Re:- Plot No. 40, Karachi Parsi Housing Society.

REVIEW FORM

PROPOSED ADDITIONS & ALTERATIONS IN BUNGALOW ON PLOT No 40.

The Land Manager & Architect,
Karachi Municipal Corporation,
K A R A C H I.**SUBJECT:-** Proposed alterations to
Bungalow on Plot No.40.K.P.C.

GROUND FLOOR PLAN.

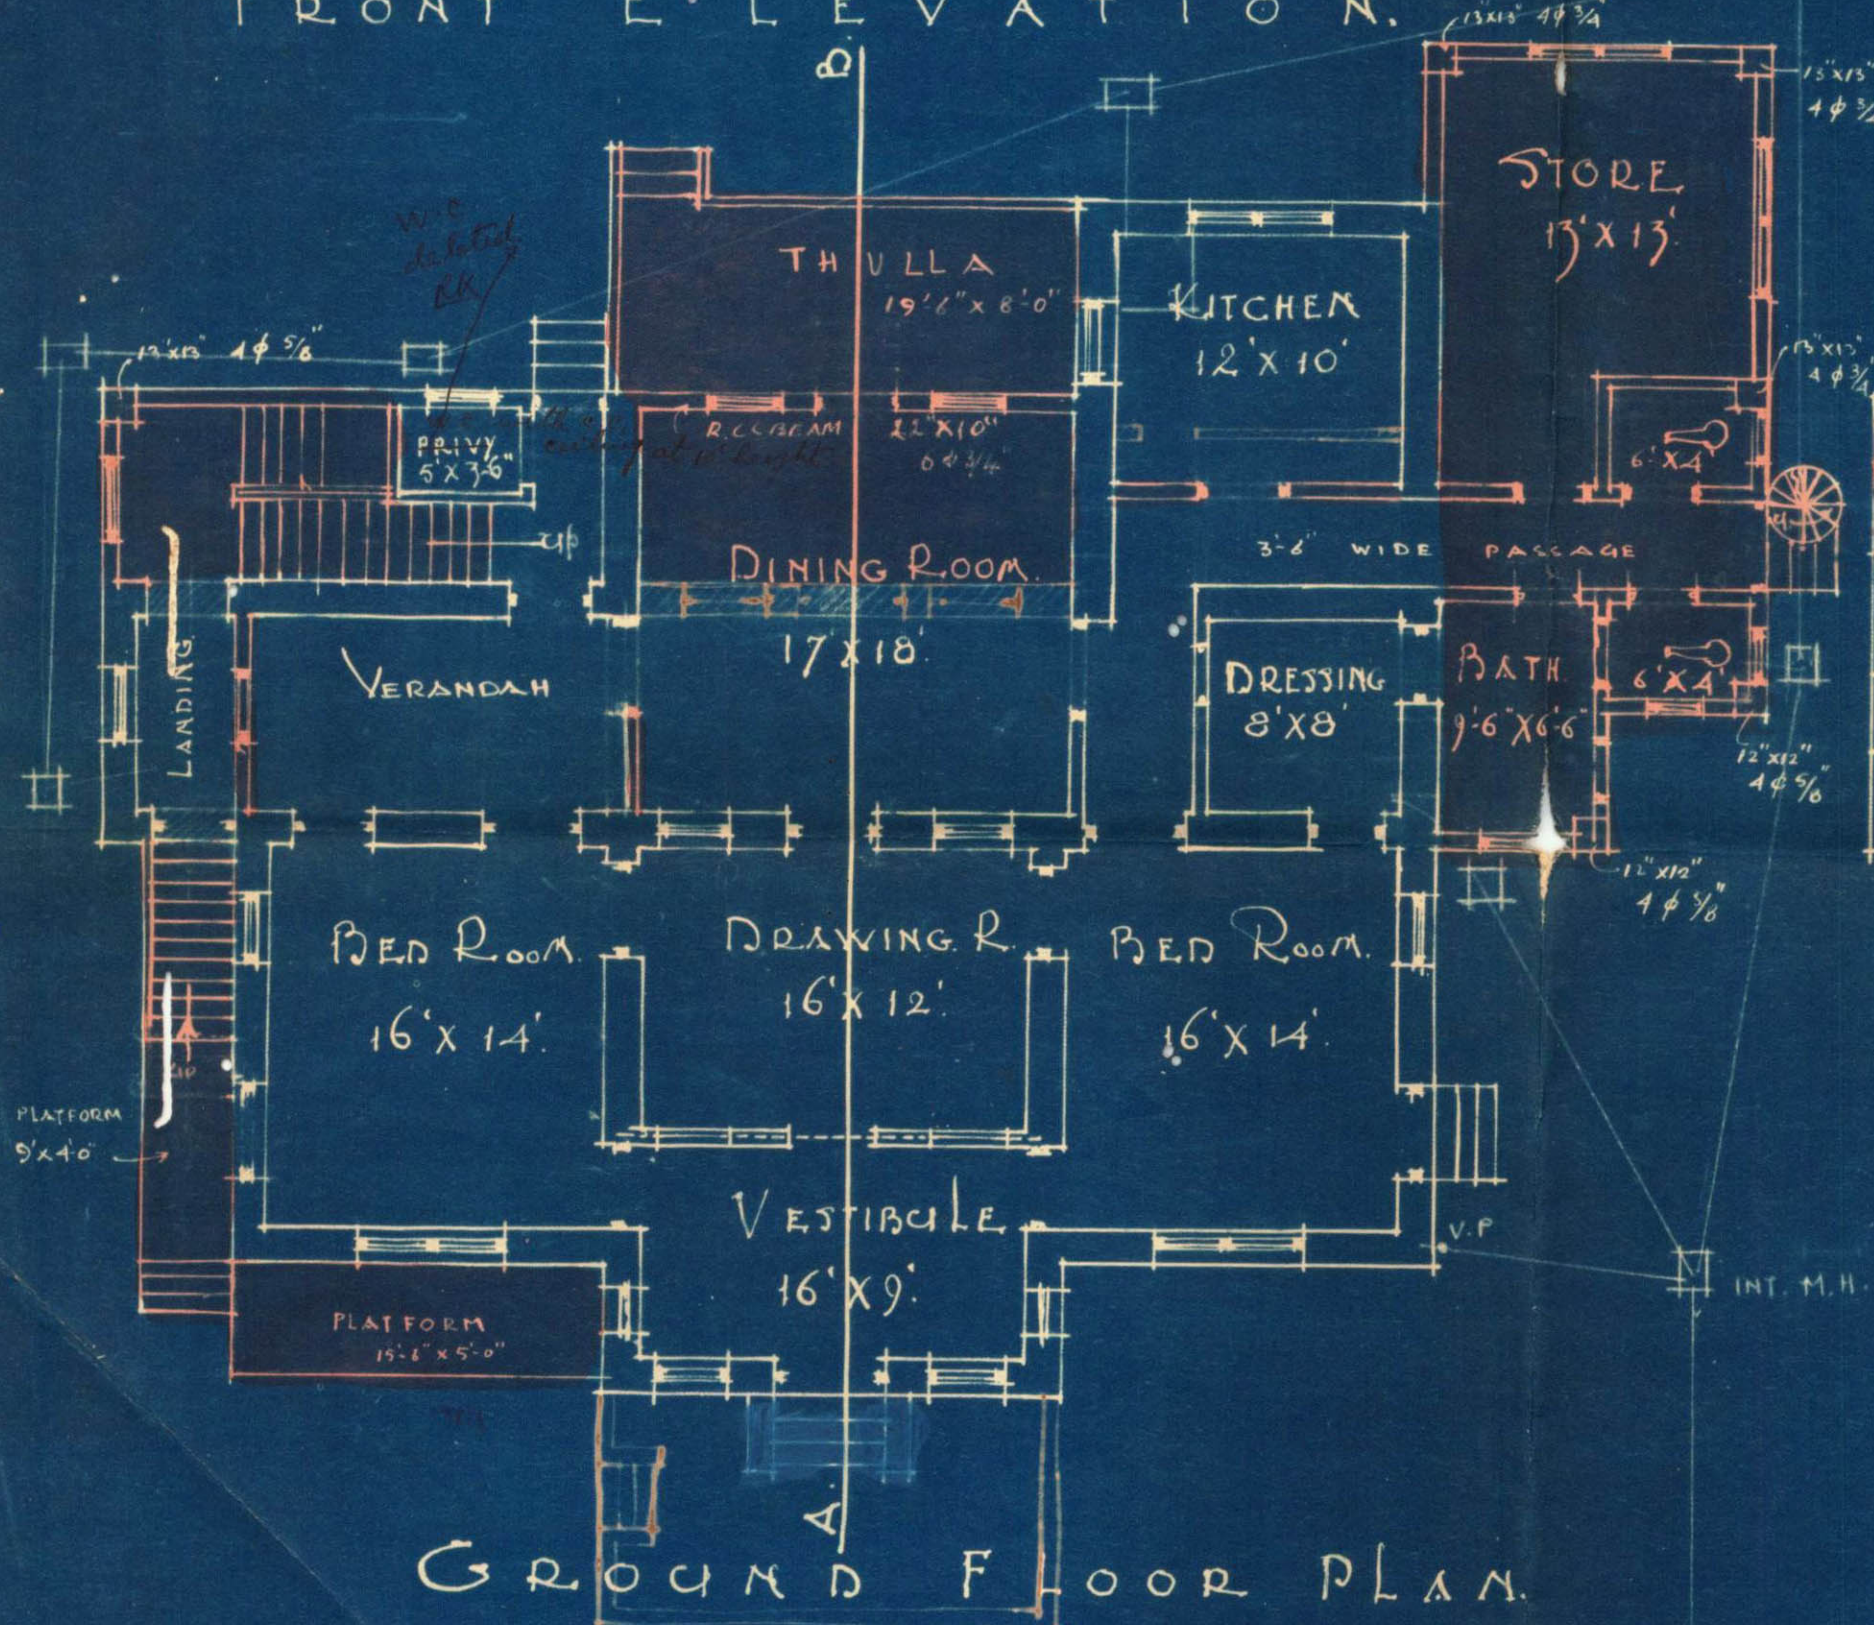
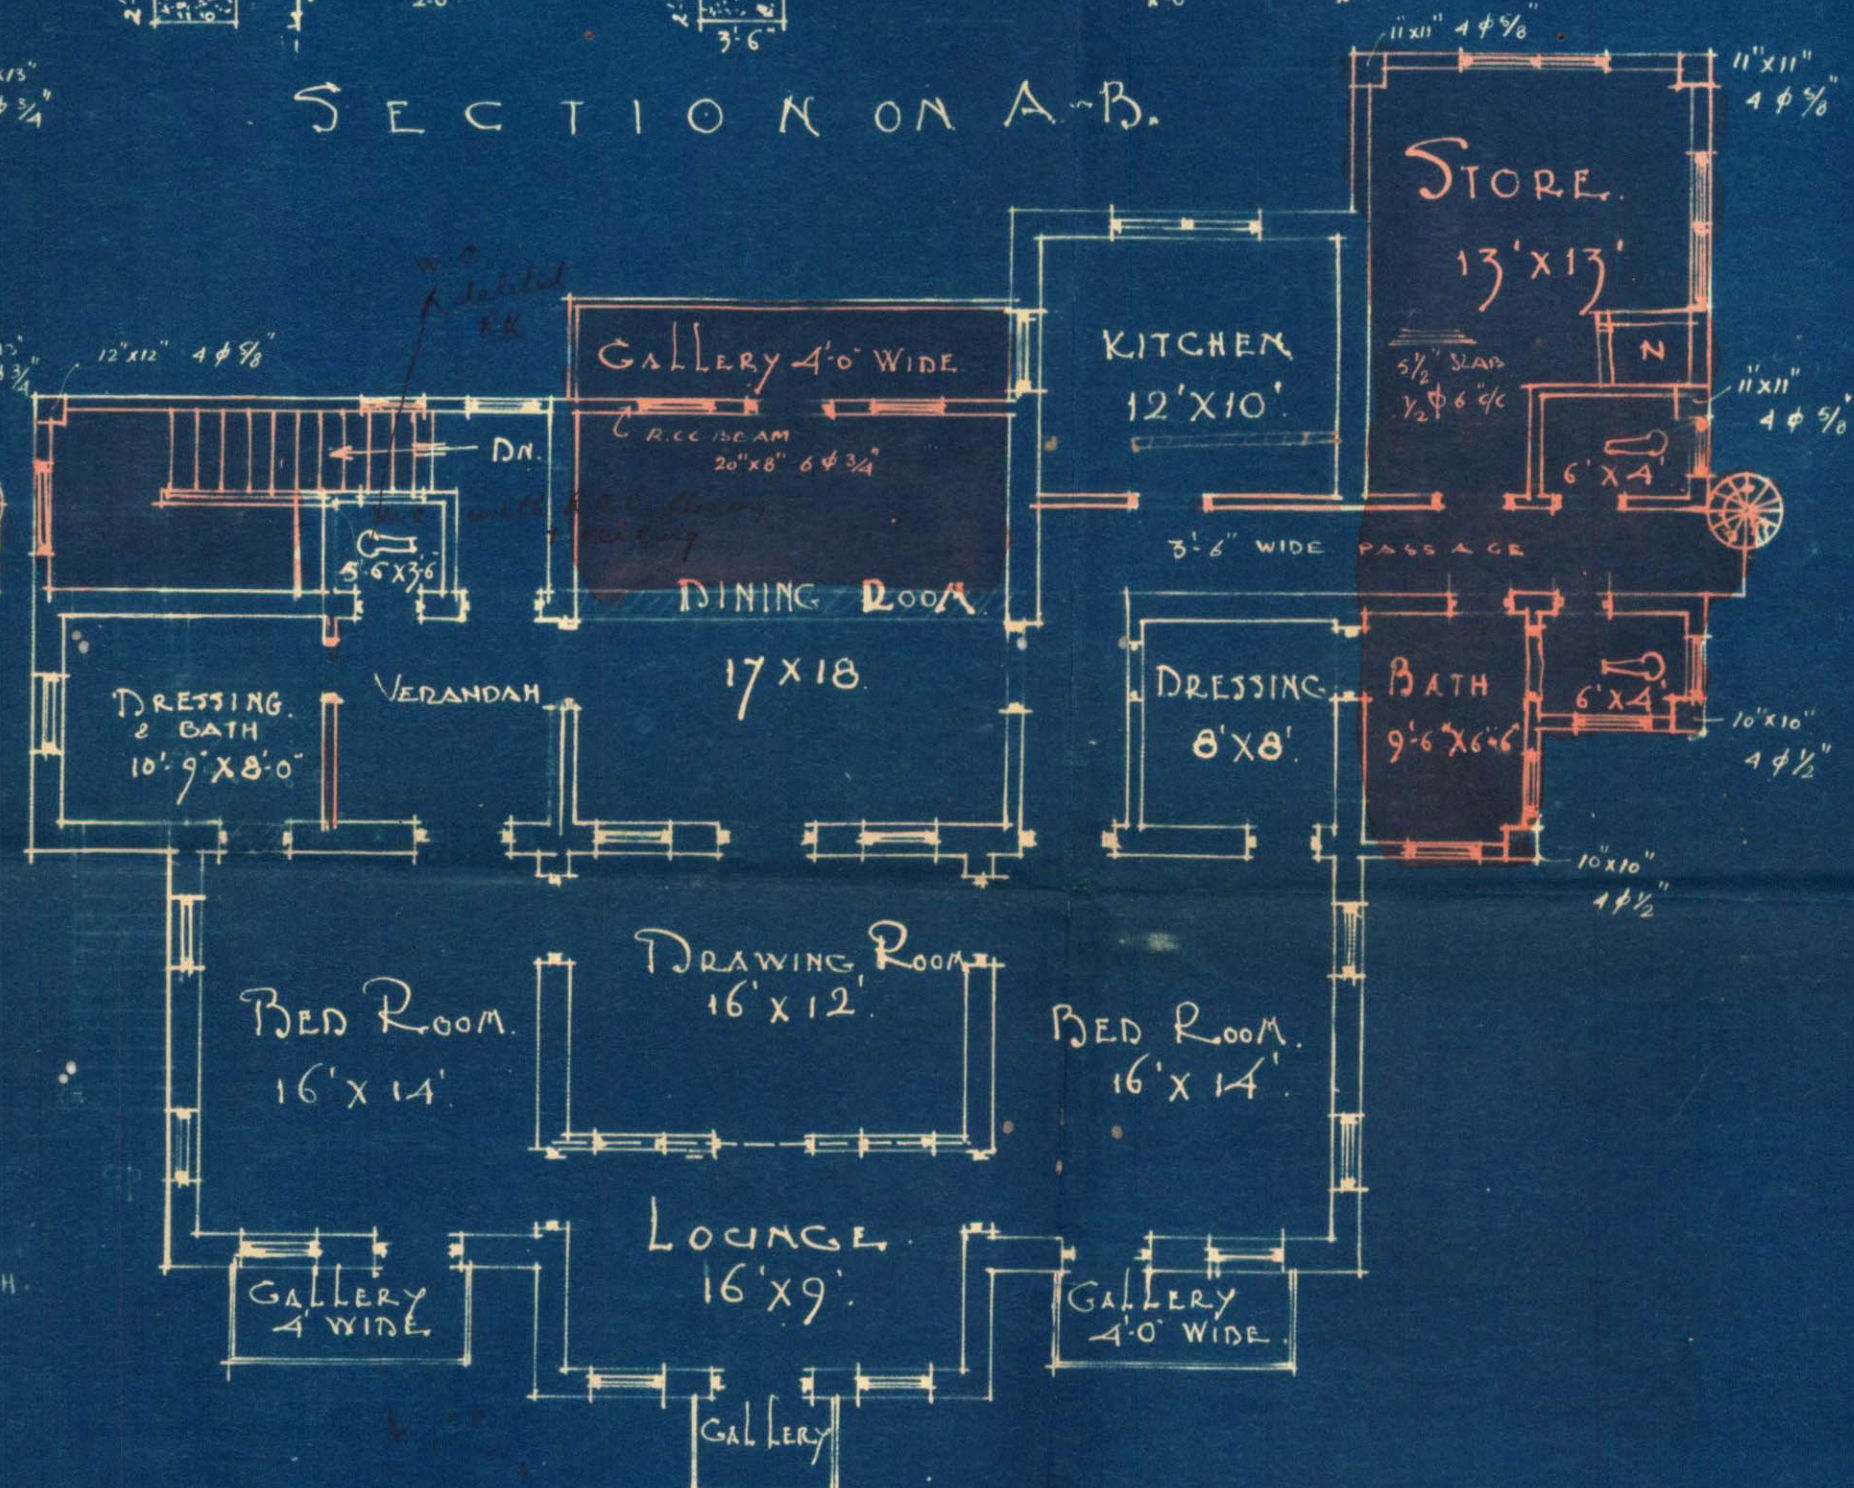
The architect has deleted the W.C.'s ~~sheet~~ for which C.O.'s sanction was necessary. There is therefore now no objection to grant the "no objection" certificate.

The architect has proposed W.C.'s above & below the staircase. Intrinsically there is no objection to them, as the floors & roofs are to be of Cement Concrete construction, but your sanction is requested vide Schedule II, Chapter I, rule 17 of the Act.

- (1) H.O. has not reviewed the plans as the plot is not within Municipal limits.
- (2) C.O.'s sanction is required for W.C. over & under staircase.

In continuation of our letter
No.523/40 dated 13th May 1940, we shall
be obliged if you kindly take the permi-
-ssion from the Chief Officer for the
W.C.'s lying above and below the staircase.

No objection if the owner gives in writing that the room in question is not meant to be a store room
Asst. Engineer 3/5
Code LAND CLERK.

The store-room is big enough to be used as a living room, as much it is being objected to as it is adjoining W.C.

With reference to the plans submitted by my Architect, Messrs Mistri & Bhedwar, I have to state that the store room shown in the plan will be used for storing purposes only and not as a living room.

This store room will not be used as a living room and it is really meant for a store for the bungalow.
